Access Compliance Report Public Rights-of-Way (RR Crossings)

Intersection ID: 12618	Main Street: E_5TH_ST	Location: N/A
ADA ID: 330226A050E6	Overall Compliance: No	Severity Score: 0.0
Codes/Mitigation Info/Possible Solution		Field Measurements/Component Compliance

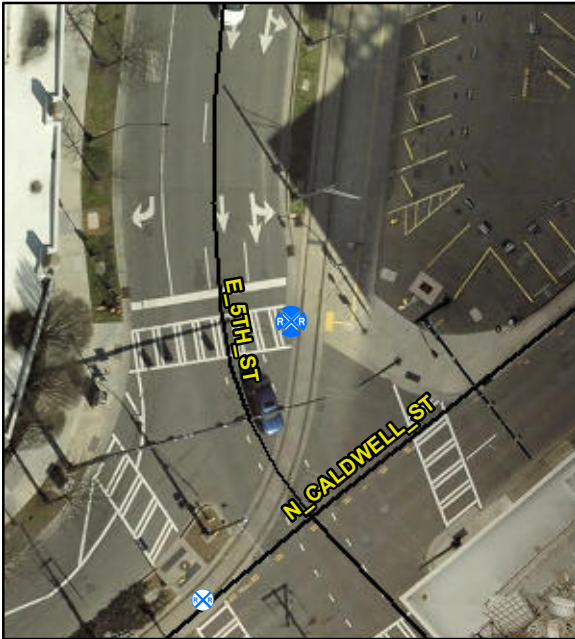
Compliance	Description	Data
Yes	DWS Provided?	Yes
Yes	DWS Contrast?	Yes
No	DWS Width (in)	No
Yes	DWS Length (in)	25.0
No	DWS Offset (in)	17.0
No	Pedestrian Gate?	No
N/A	DWS Outside Gate?	No
N/A	Rail Type?	LightRail
Yes	Flangeway Gap (in)	2.0
Yes	Sidewalk Width (in)	80.0

**Remove & Replace Detectable
Warning System. Provide Pedestrian
Gate.**
